**PLANNING COMMISSION MEETING**  
**Tuesday March 12, 2024**  
**7 PM**

- a. Public hearing to consider a development application of Medart Inc. for an administrative subdivision, easement vacation, and PUD amendment/site and building plan for the development of a 105,157 sq. ft. industrial building on Lots 1 and 2, Block 1, AVA Second Addition. (page 5-23, Exhibits A-J)
- b. Public hearing to consider a sign code text amendment allowing signs within City playfields within Central Park - Tabled from February 13, 2024, Planning Commission meeting. (pages 24-27, Exhibit A)

TO: Adam Nafstad  
FROM: Alan Brixius  
DATE: February 27, 2024  
RE: Medart Industrial  
FILE NO: 163.06 24.01

**SITE PLAN**

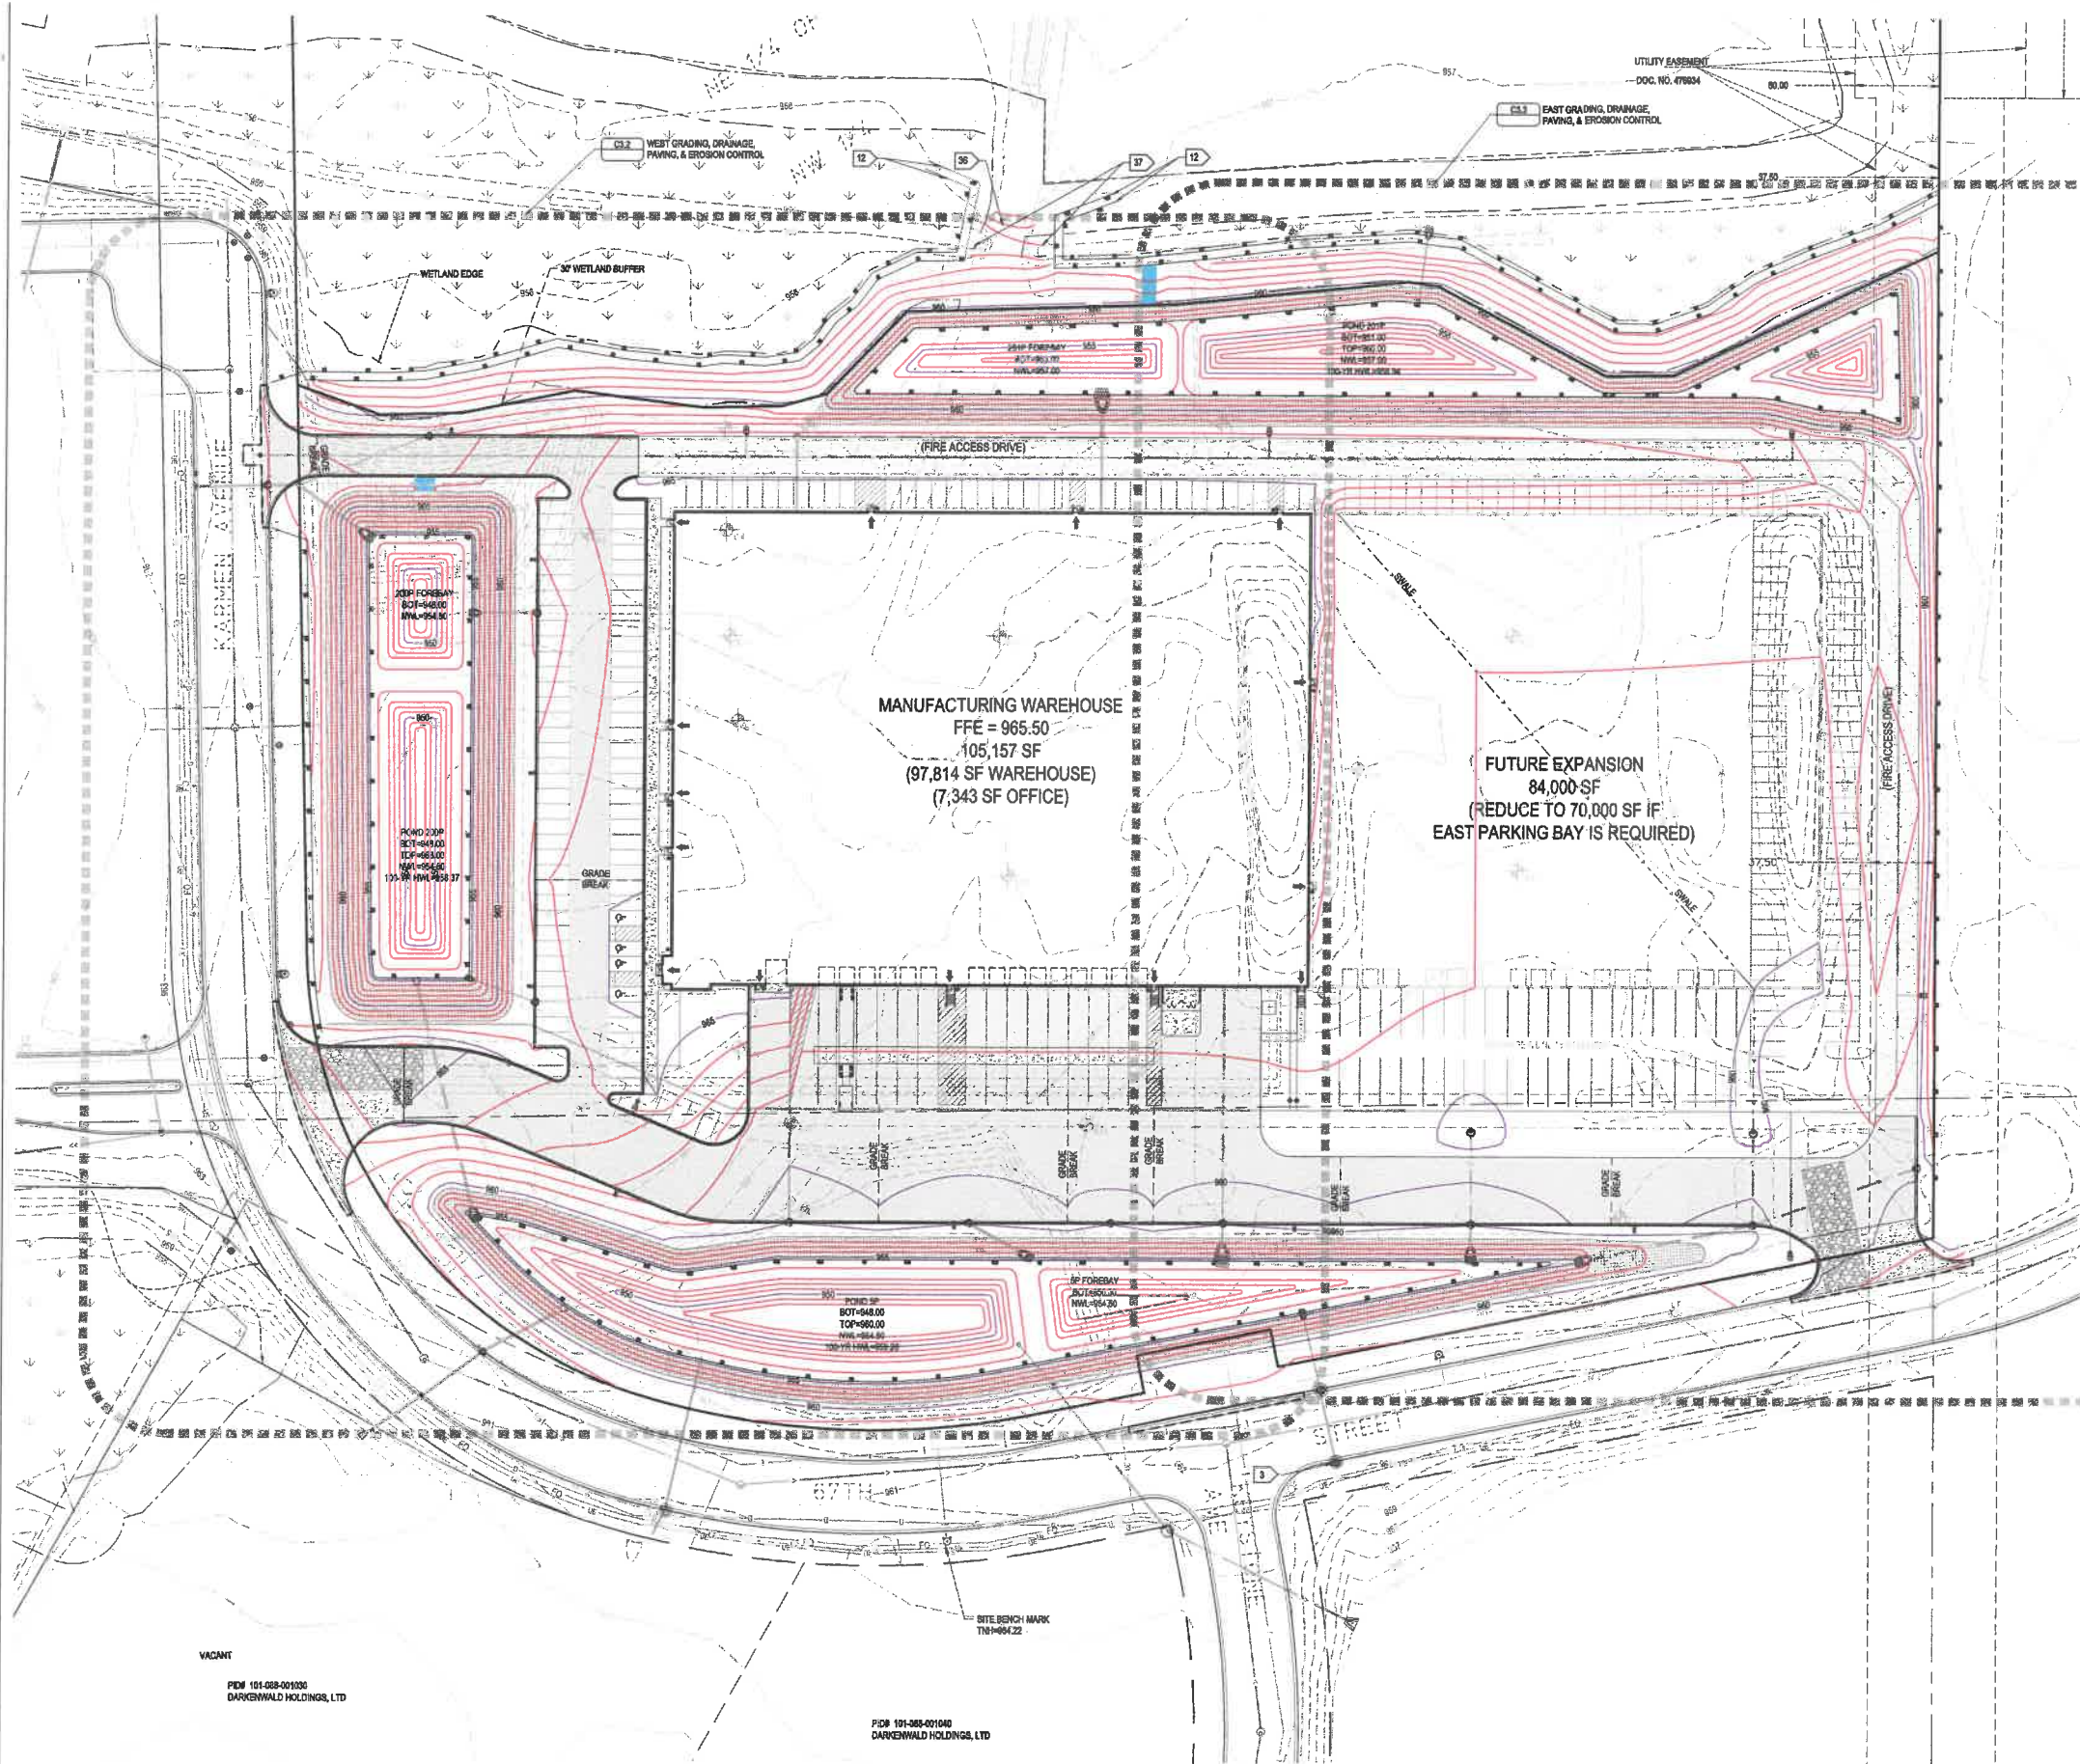
1. The proposed site plan shows three curb cuts serving the site. The site size and street frontage allow this number of curb cuts.
2. The proposed southern curb cuts at south and west property lines measure 62 and 65 feet in width. By City Code, the maximum curb cut width is 24 feet unless otherwise approved by the City Engineer. The City Engineer will review the proposed curb cuts and provide a recommendation for an acceptable curb cut width as a PUD flexibility.

3. The site plan design segregates the automobile parking from the loading area.
4. By code all drive aisles are required to be paved with bitumen or concrete. The applicant is proposing a 24 foot drive aisle around the building with a gravel surface. This drive aisle will serve as a fire lane around the building and will be improved with the future building addition or if additional parking is required. The City may allow a temporary exemption for paving this drive aisle through PUD flexibility provided the gravel drive aisle is designed to meet the 2020 Minnesota State Fire Code, Fire Apparatus Access Road for all-weather access. Staff also recommends that this drive aisle be improved to a paved surface by October 2030 or with the future building addition whichever is sooner.

Disability parking stalls. The site plan shows 4 disability parking stalls within the west parking lot. These disability parking stalls are adequate for the 73 stalls. As additional stalls are built the number of disability stalls must be increased. The site plan shows a total of 214 parking stalls this will require 6 disability stalls. The site plan must show the location and design of the 6 disability stalls.

Trash Handling. The site plan shows the location of an outdoor trash enclosure on the south side of the building. Exterior trash enclosures are to be designed to match the building. Applicant shall provide a detail of the side walls and gates showing materials and design.

1. The City Council repeals the 2022, PUD approval for Albertville Self-Storage for the same lot.
2. The site plan be revised to implement the City Engineer's recommendation for curb cut widths for the site.

3. The City approves PUD flexibility for a gravel fire lane around the north and east side of the building per the approved site plan. The gravel drive aisle shall be designed to meet the 2020 Minnesota State Fire Code, Fire Apparatus Access Road for all-weather access. The gravel fire land shall be improved to a paved surface by October of 2030 or with the future building addition whichever is sooner.

- All parking shall be designed and constructed to meet City parking standards.
  - The site plan shows a total of 214 parking stalls this requires 6 disability stalls. The site plan must be revised to show the location and design of the 6 disability stalls.

5. The Applicant shall provide a design detail of the proposed trash enclosure showing the exterior materials of the enclosure and gate.
6. The site and landscape plan must be revised to show landings and sidewalks for the doors on the north and east sides of the building. These landings and clear paths shall be kept clear of obstructions and snow from the doors to a drive aisle.

**BUILDING ELEVATIONS**

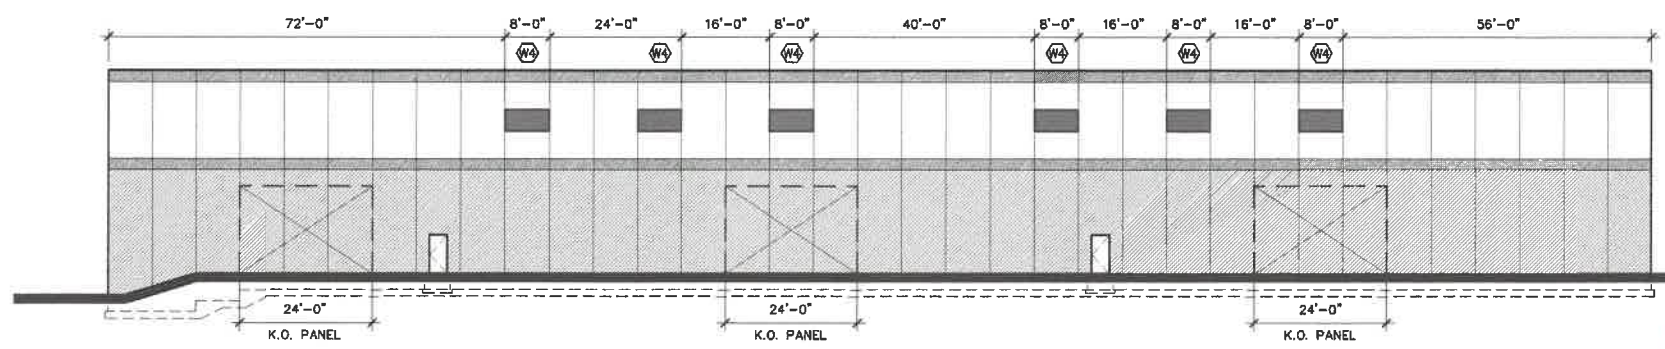
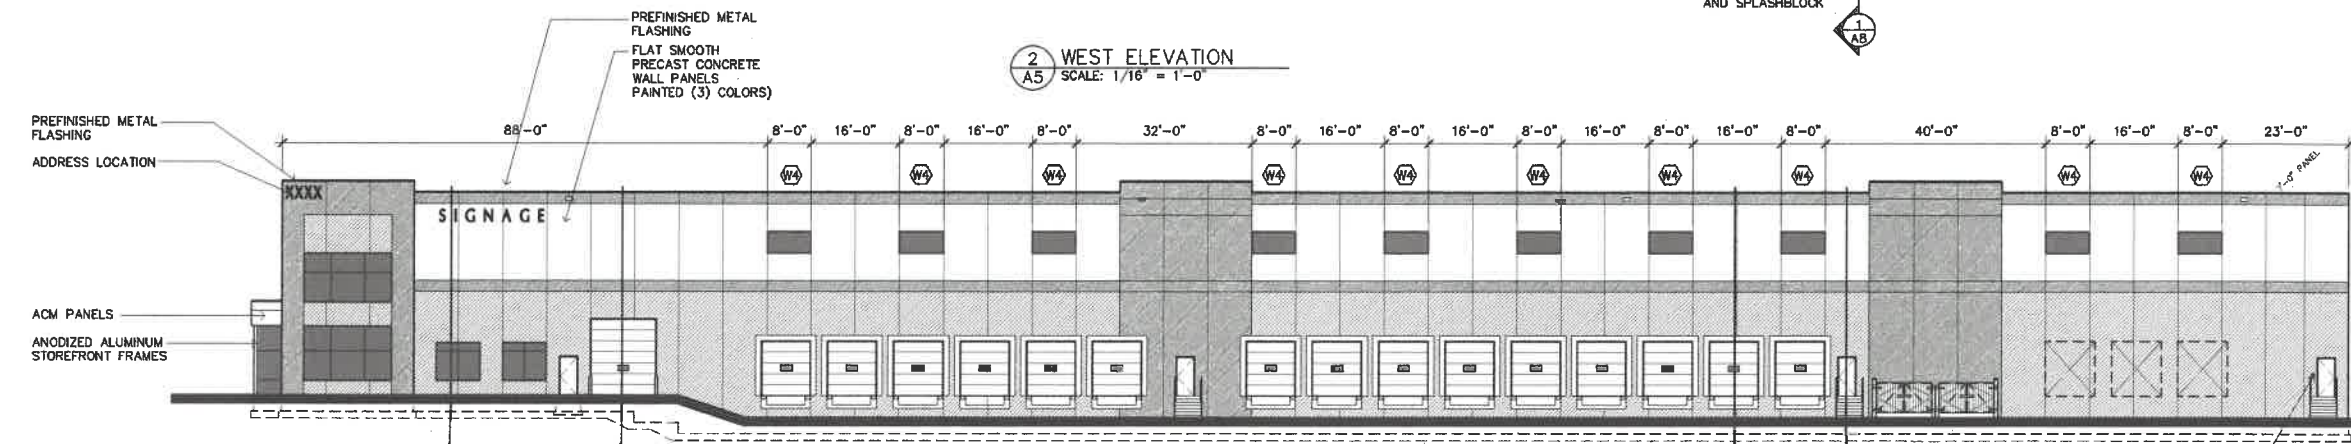
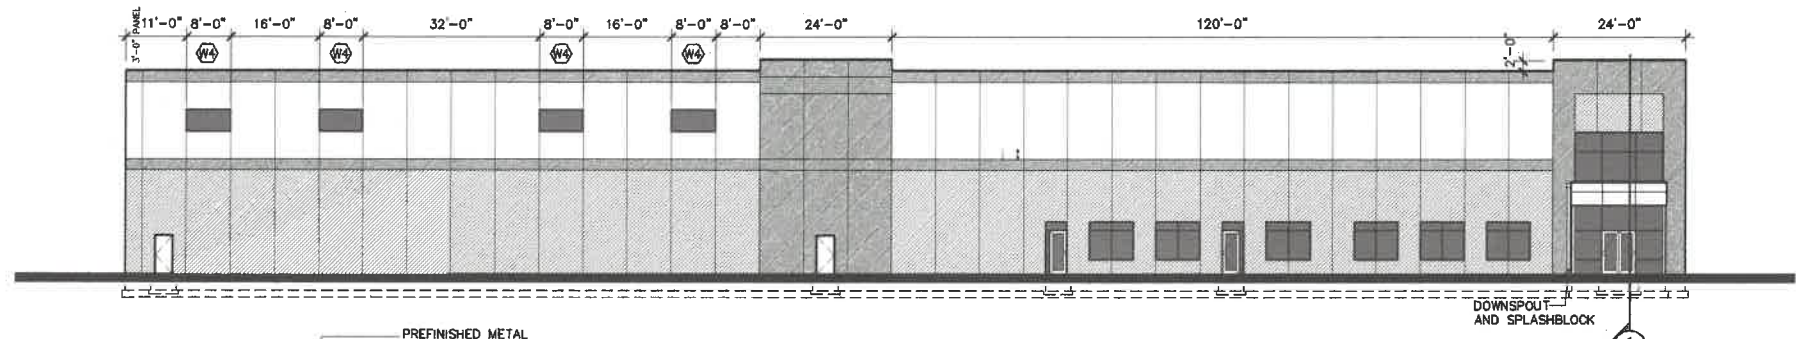
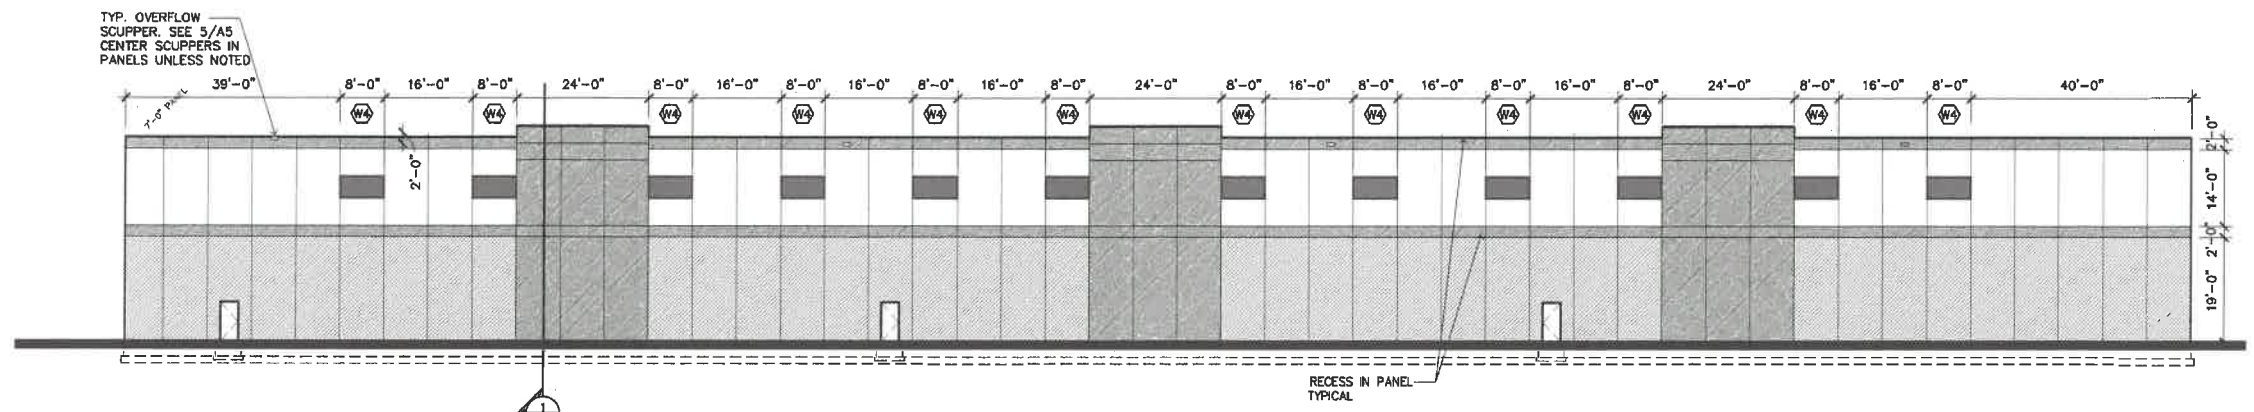
Building Materials. The Building Elevations show the exterior building treatments for each of the buildings. The building will be constructed of precast concrete panels painted with three colors. The building materials meet the I-2 district standards.

Signage. The building elevations show wall signs on the south side of the building. A separate sign permit shall be required with the submission of the building permit. The sign permit shall address the following details.

9. The lighting plan be revised to include one additional wall mounted light over the man door at the northwest corner of the building.
10. A separate sign permit shall be required with the submission of the building permit showing wall signs, freestanding signs and any on-site directional or traffic control signs.
